STATE OF OREGON WATER WELL REPORT (as required by ORS 537.765)

(1) OWNER: Name Butte Creek School, Address 37569 S. Hwy 213, City Mt. Angel, State OR, Zip 97362

The Water Resources Department has received your request for special standards on the Butte Creek School well located in Township 6S, Range 1E, Section 9 of Clackamas County.

REQUEST FOR WRITTEN APPROVAL TO USE CONSTRUCTION METHODS NOT INCLUDED IN OREGON ADMINISTRATIVE RULES 690-200 THROUGH 690-240

(7) Diagram showing the pertinent features of the proposed well design and construction:

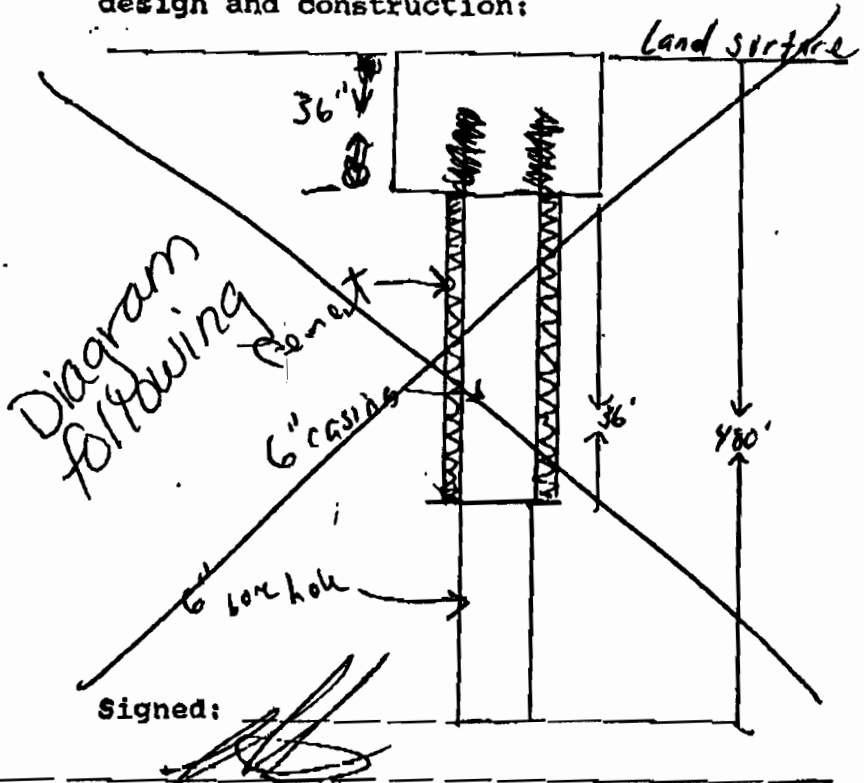
Install 3'x3'x2' Vault with drain
To allow safety on school play ground

Due to the location of the well within a ball field, you are proposing to place the well head within a vault. Your request is approved as written with the following conditions:

1. The vault shall have a cover designed to withstand expected loadings.
2. A water-tight casing cap shall be installed.
